*COMMENTS ON ANY
FURTHER INFORMATION /
SUBMISSIONS RECEIVED BY
DEADLINE 3*

Cowfold Residents' Comments at Deadline 4

Version 1 – 30 May 2024

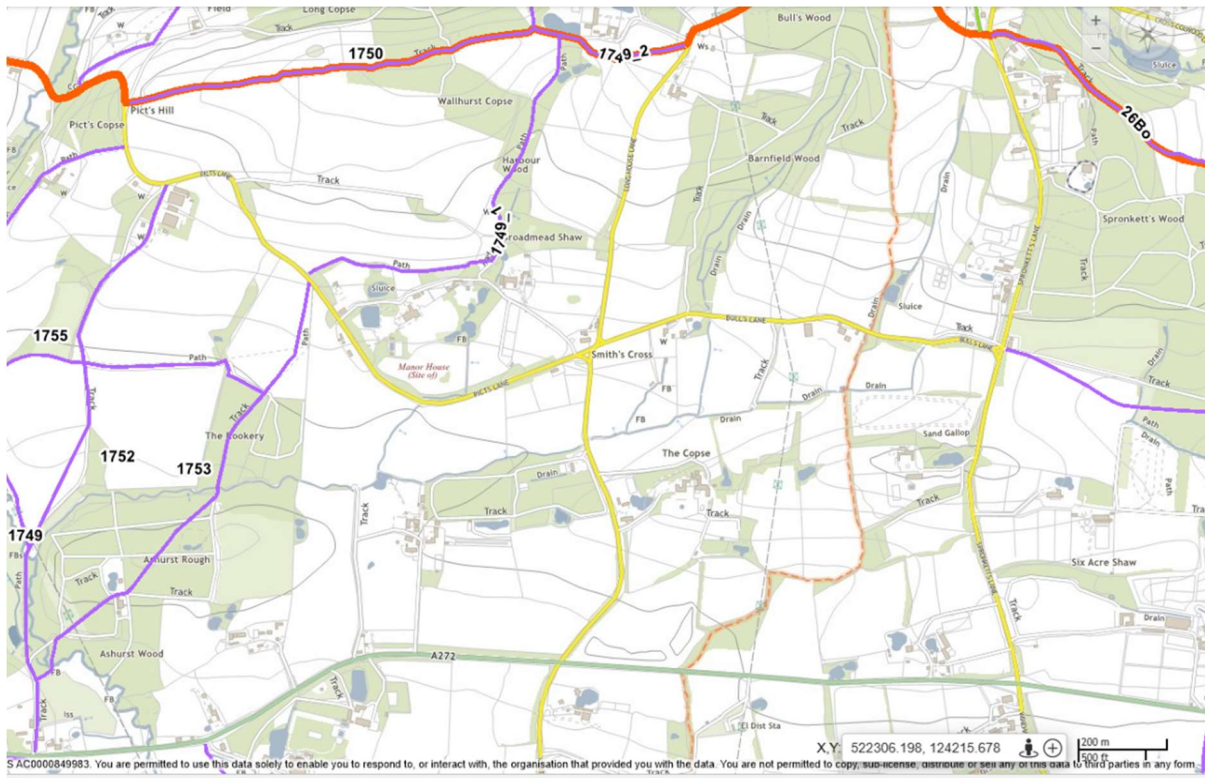
6.3.18 part 5 of 6 fig 18.57 Viewpoint M is approximately 5km away from the substation location. It is representative of Rampion's aim to deceive rather than inform that they chose this for the substation viewpoint rather than one 300m away directly north of the substation. Indeed, they make some attempt to look nearer but then exclude the viewpoint:

From 6.3.18, part 5/6 *“Viewpoint SA6: PRoW 1750 north of Aglands This viewpoint has been omitted from the LVIA as there is no visibility of the onshore substation and onshore cable corridor.”* However, please note that the PRoW 1750 runs from Picts Lane to Longhouse Lane. **The lowest point on this footpath is due north of Aglands, at approx. 52 m above sea level the highest is directly north of the substation, behind Walhurst manor at 72m.**

What is the justification for choosing the lowest point rather than the highest, especially as the latter is open to the south and would have had a far better view down to Oakendene than either viewpoint M or Viewpoint SA6?

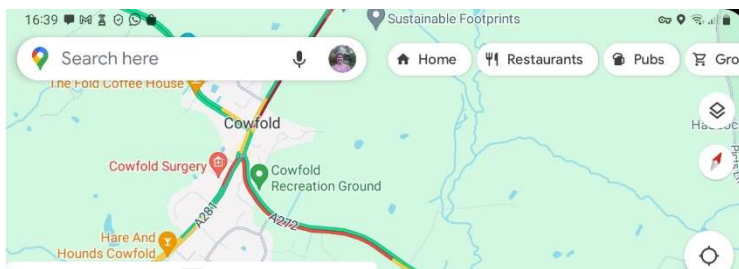
5.2.15 of the Stantec report says "The measure used to assess this is the volume to capacity ratio or V/C. This effectively indicates how arms on junctions are performing based on the flows predicted in the model and the modelled capacity of each arm at a junction. When a junction goes over capacity, there will be increases in delays experienced by travellers as flows increase. Therefore, if Local Plan development increases the flows, this will exacerbate any existing issues or lead to new issues of excessive delays at a junction. "

This confirms the modelling arguments in traffic and air quality chapters of the Cowfold v Rampion Impact Statement (REP1-089) and appendix 4 in deadline 3 submission REP3-099

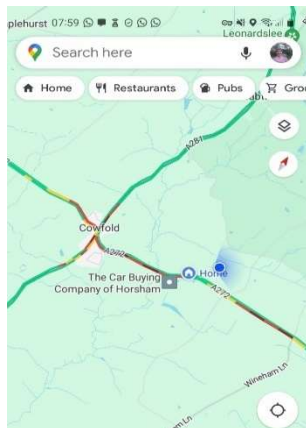
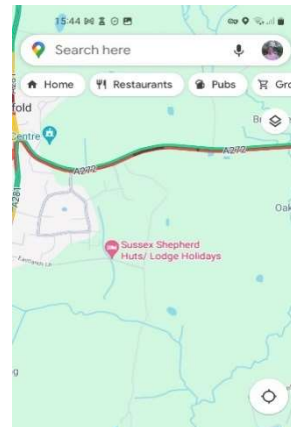
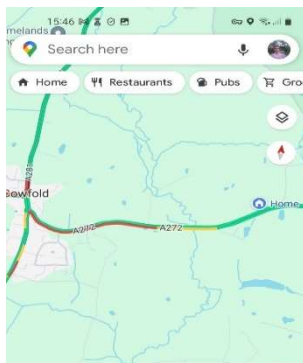
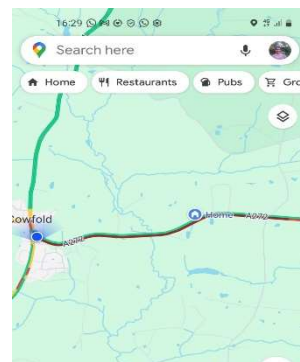
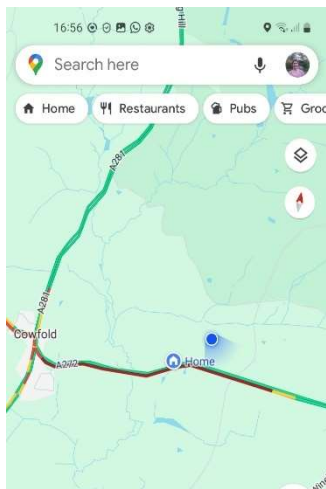
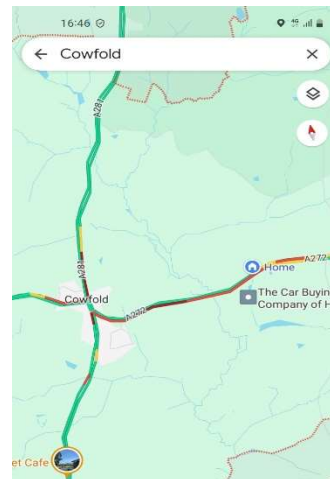
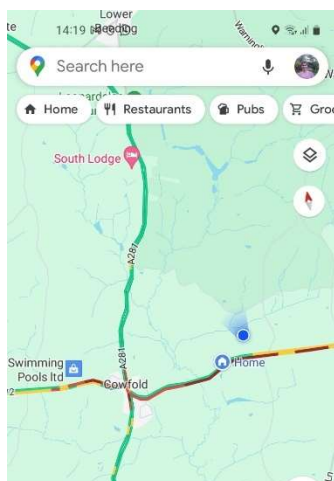
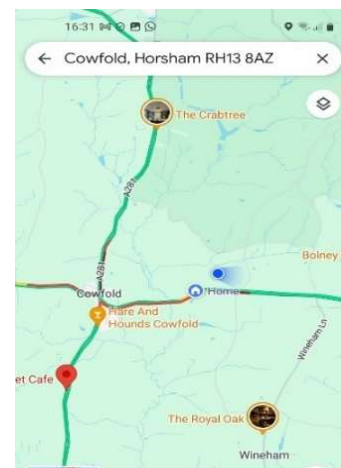
This is evidenced by the following screenshots, taken since the beginning of March, which show numerous instances of the traffic at a standstill on the A272 outside of peak times. Please note that these are representative only and do not include **all** such episodes.

This is exactly as experienced by residents and why the additional vehicles from Rampion WILL make a difference, as will the congestion caused by the vehicles turning on and off into the compounds, causing the traffic to back up into the AQMA
